RECORD DRAWINGS

# Kingston Public Library

Title  
Site Plan

No. A-0

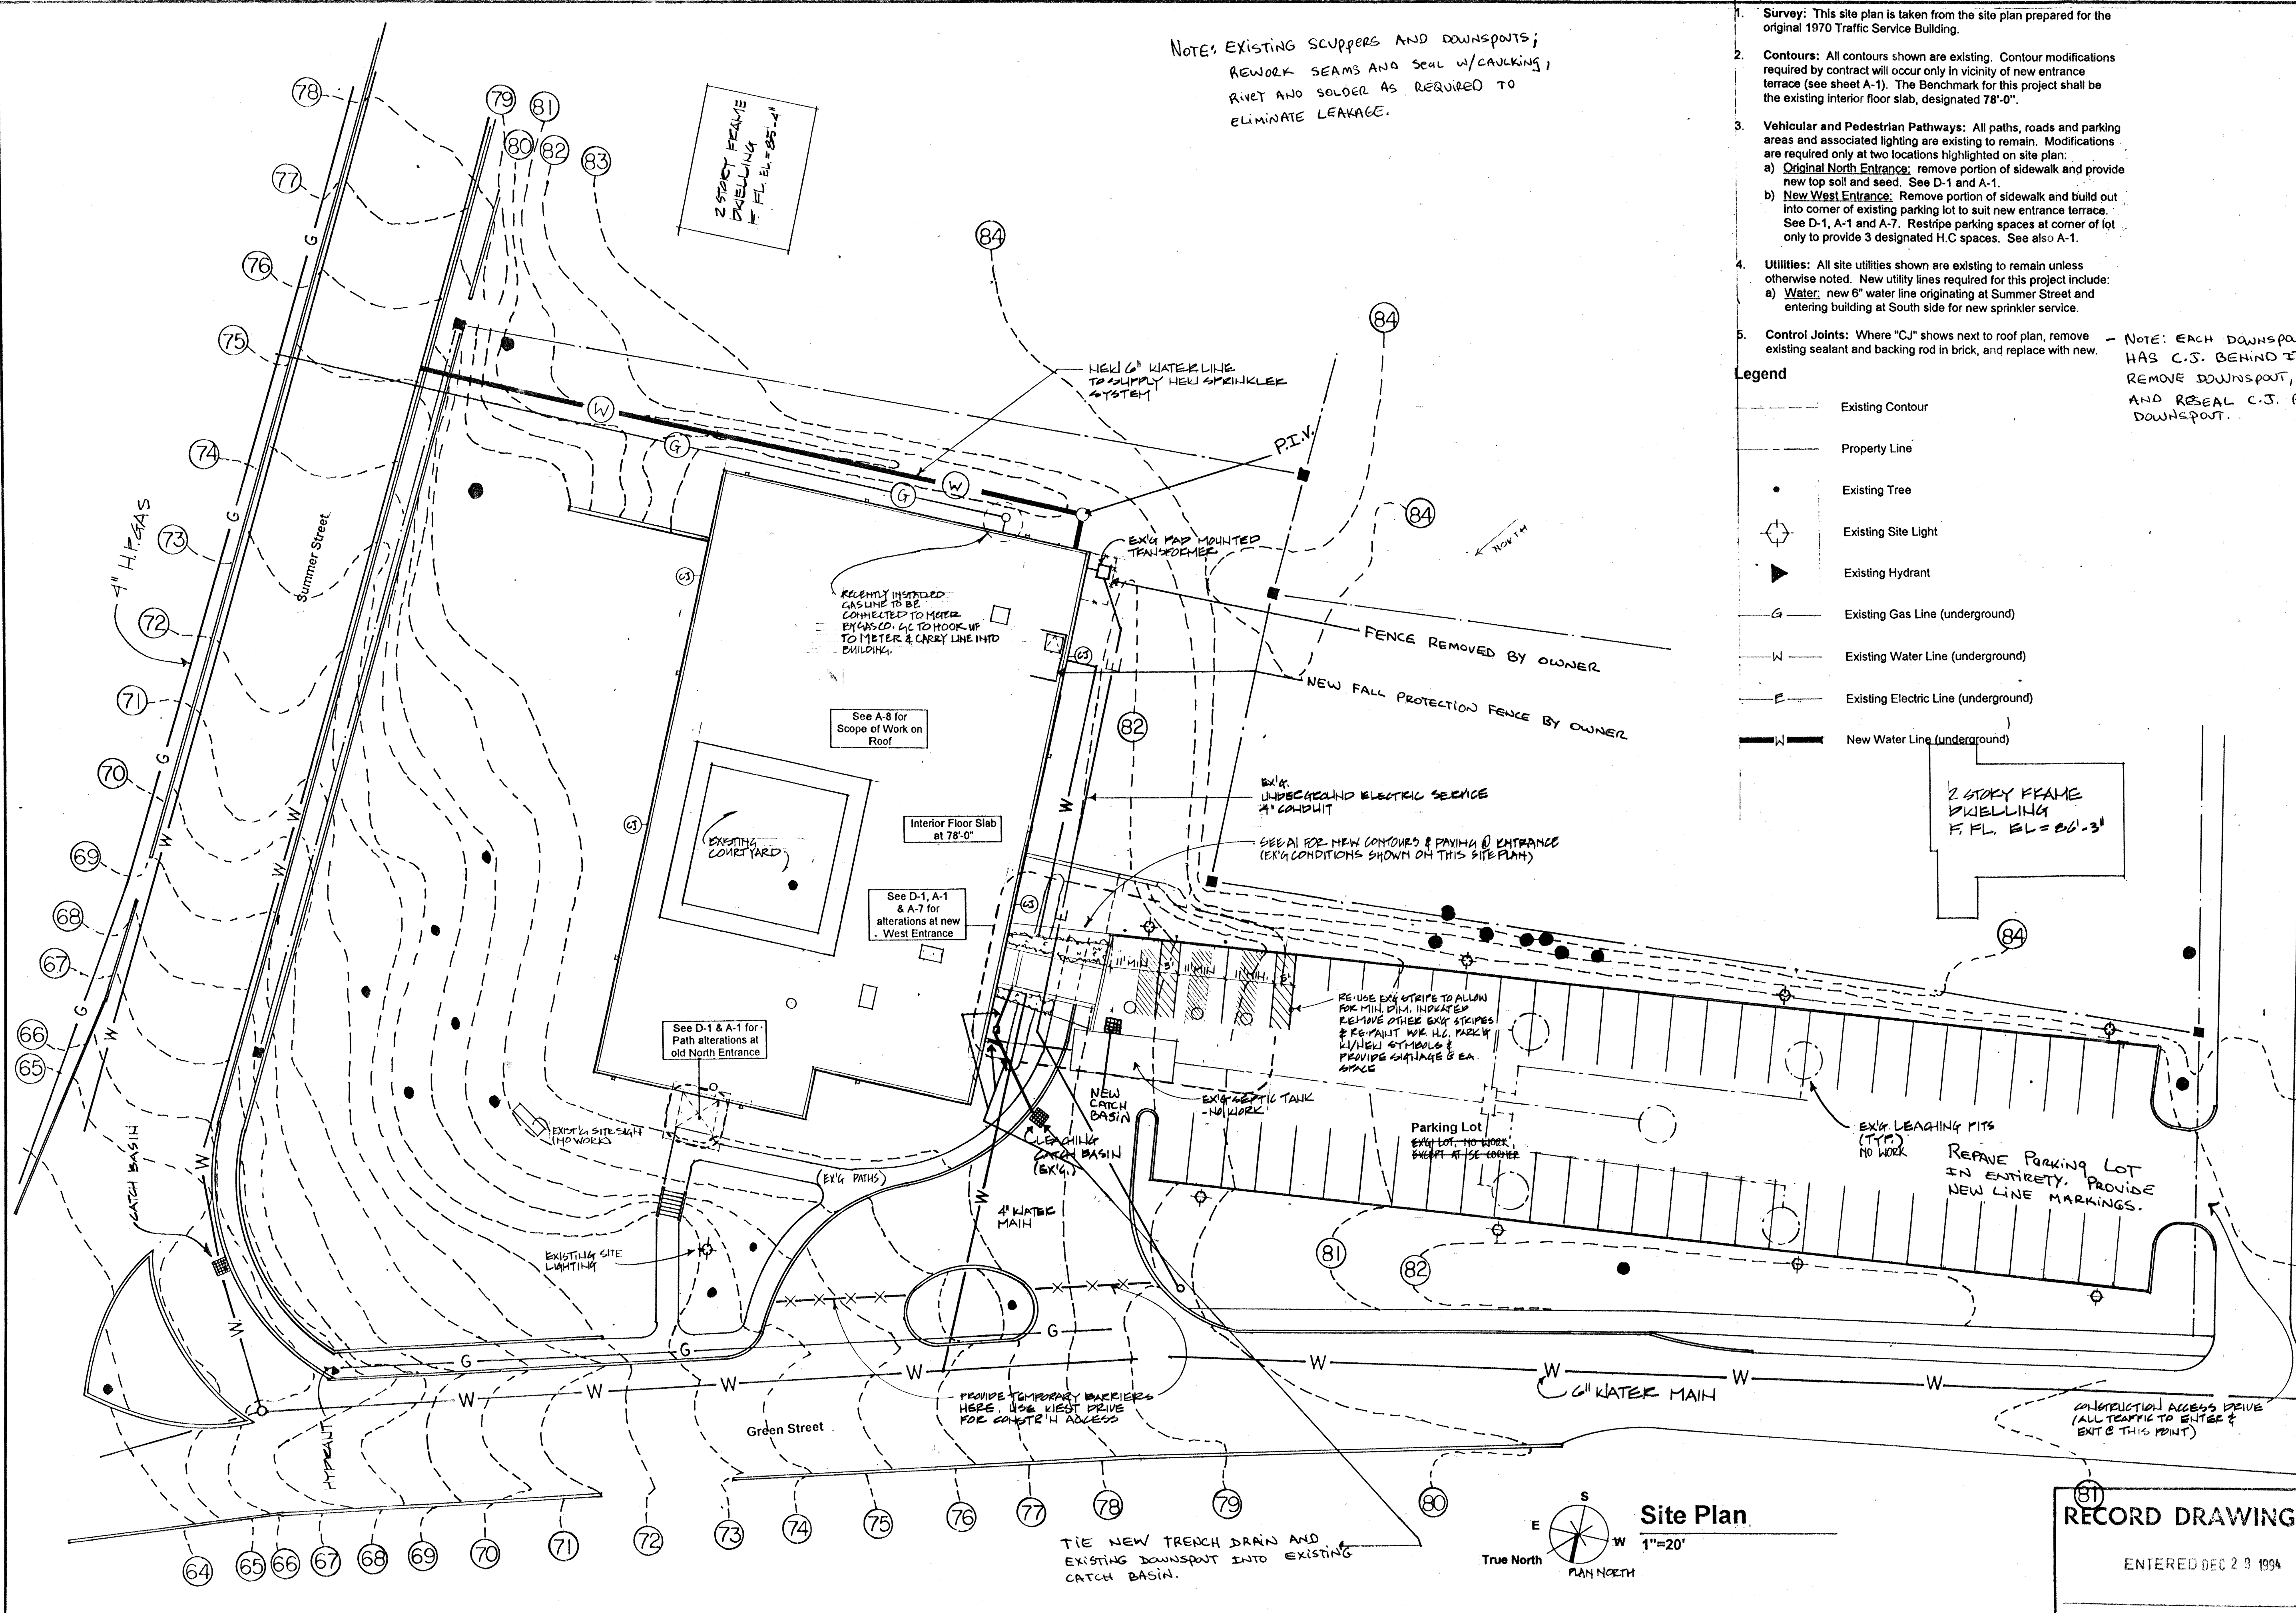
NOTE: EACH DOWNSPOUT HAS C.S. BEHIND IT. REMOVE DOWNSPOUT, REMOVE AND RESEAL C.S. REINSTALL DOWNSPOUT.

NOTE: EXISTING SCUPPERS AND DOWNSPOUTS; REWORK SEAMS AND SEAL W/CAULKING; RIVET AND SOLDER AS REQUIRED TO ELIMINATE LEAKAGE.

No. **A-1**

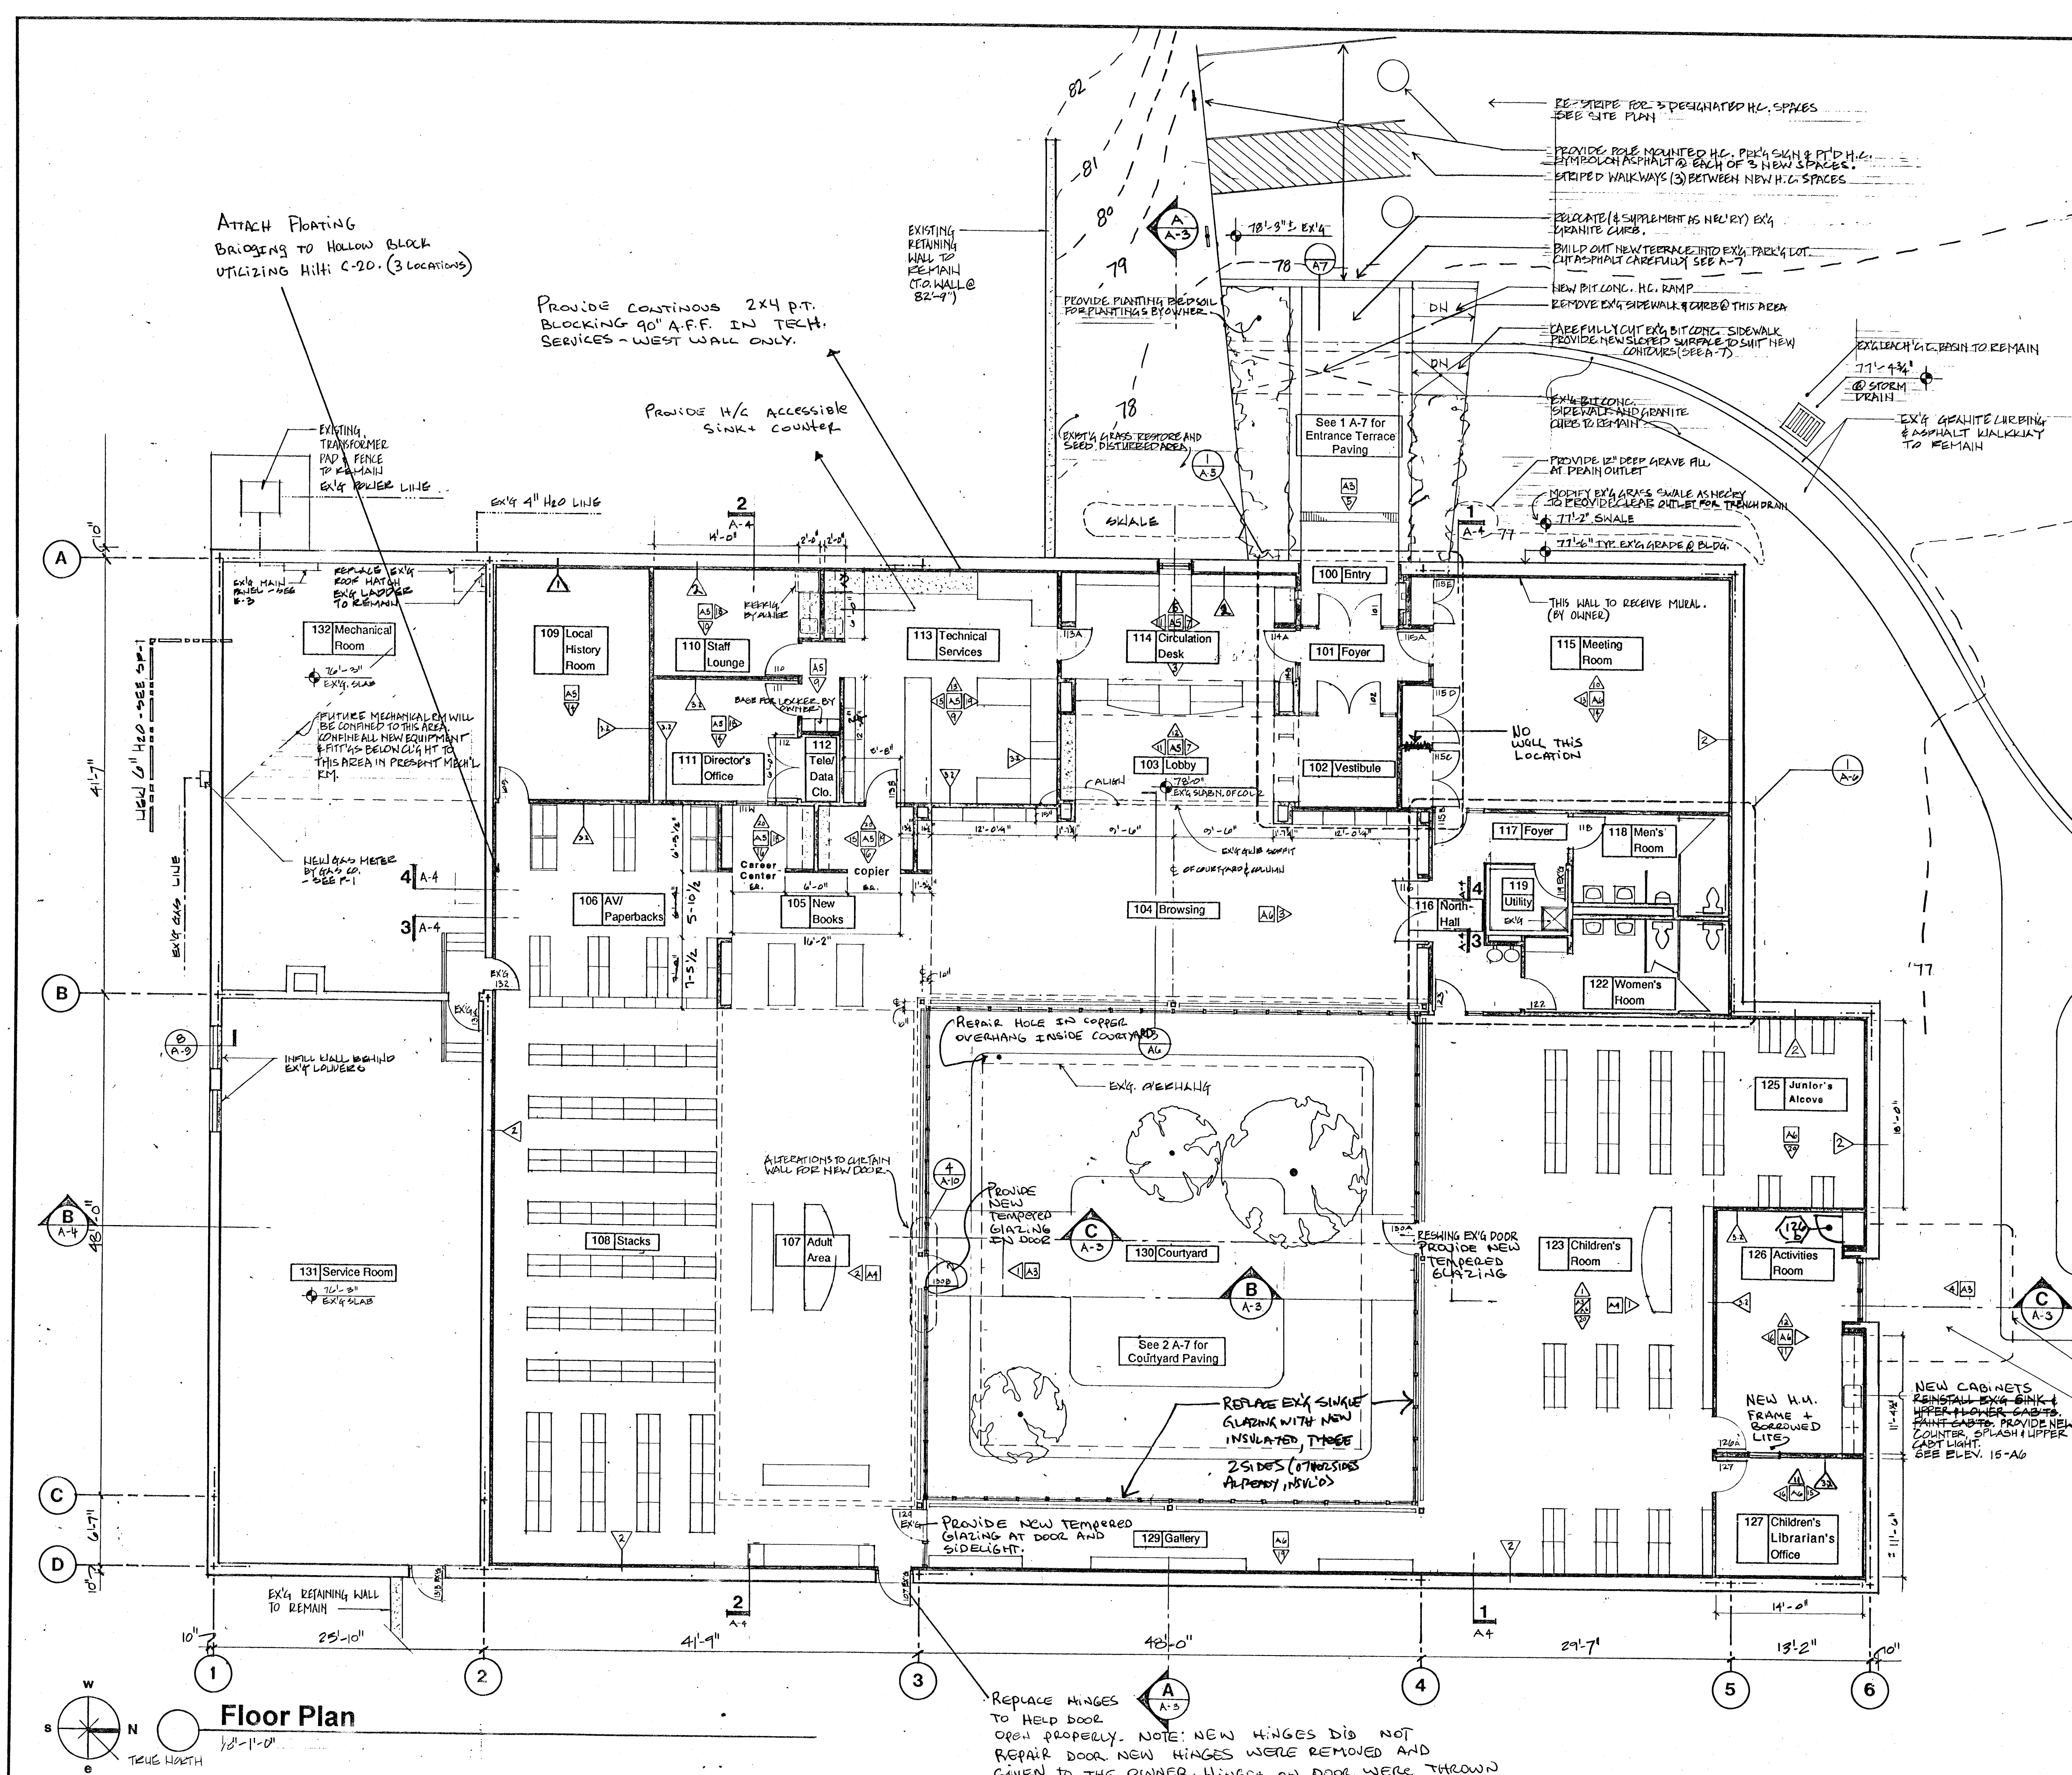
REPLACE HINGES TO HELP DOOR OPEN PROPERLY. NOTE: NEW HINGES DID NOT REPAIR DOOR NEW HINGES WERE REMOVED AND GIVEN TO THE OWNER. HINGES ON DOOR WERE THROWN AS A TEMPORARY MEASURE.

Title  
ROOF PLAN, SCHEDULES & DETAILS  
Date FEB. 9, 1994  
Scale AS NOTED

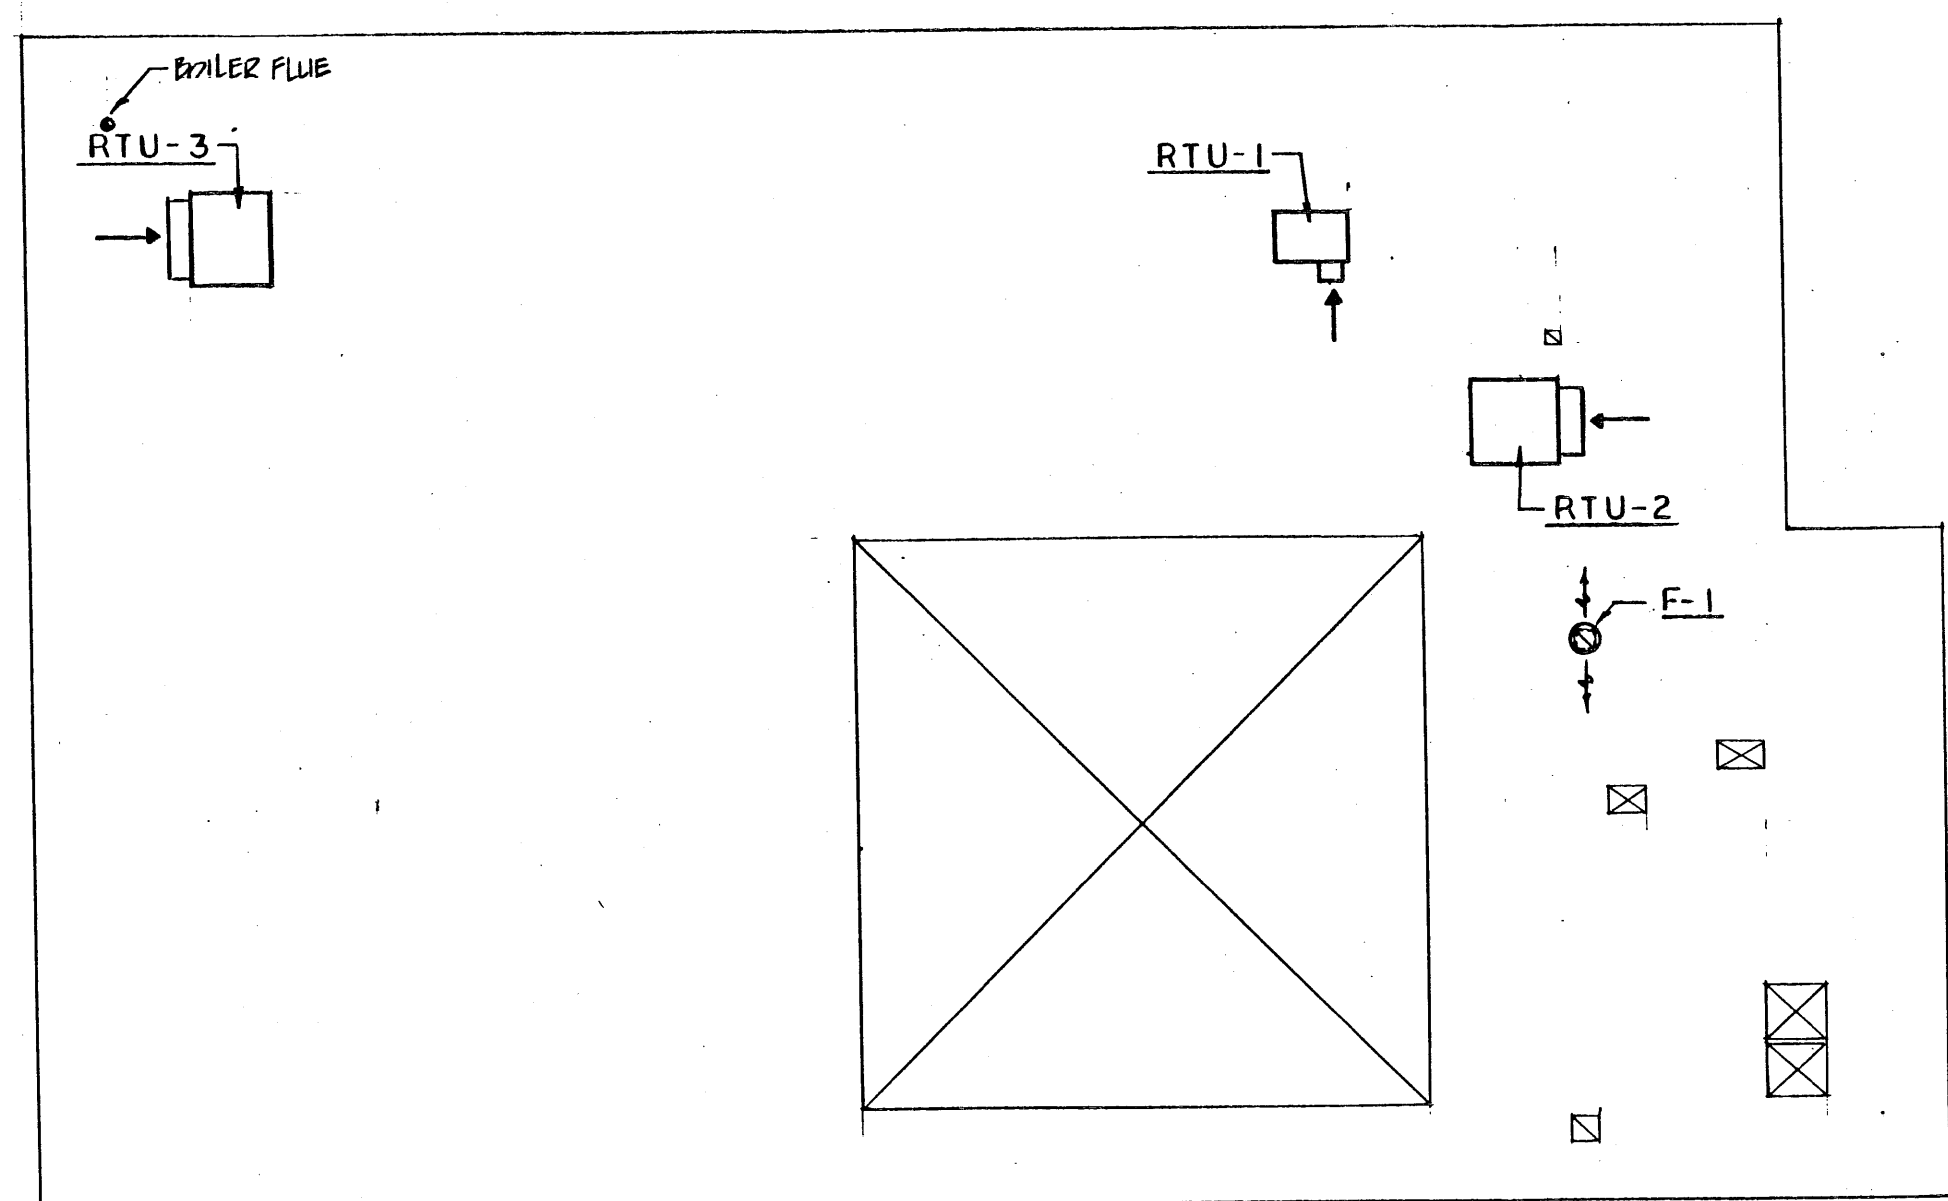
RECORD DRAWING REVIEW		93041
ENGINEER'S REVIEW	REPRESENTATIVE	
No exceptions taken	Approved	
Note markings	Confirmed	
	Accepted	
Engineer's review for general conformance with the design contract and contract documents. Markings or comments shall not be construed as relieving the Contractor from compliance with the project plans and specifications, nor discontinue the work. The Contractor remains responsible for details and accuracy, for verifying and correcting all quantities and dimensions, for selecting fabrication processes, for techniques of assembly, and for performing the work in a safe manner.		
By: CH		Date: 12-27-94
UPDATE SCHEDULES TO REFLECT CHARACTERISTICS OF INSTALLED EQUIPMENT.
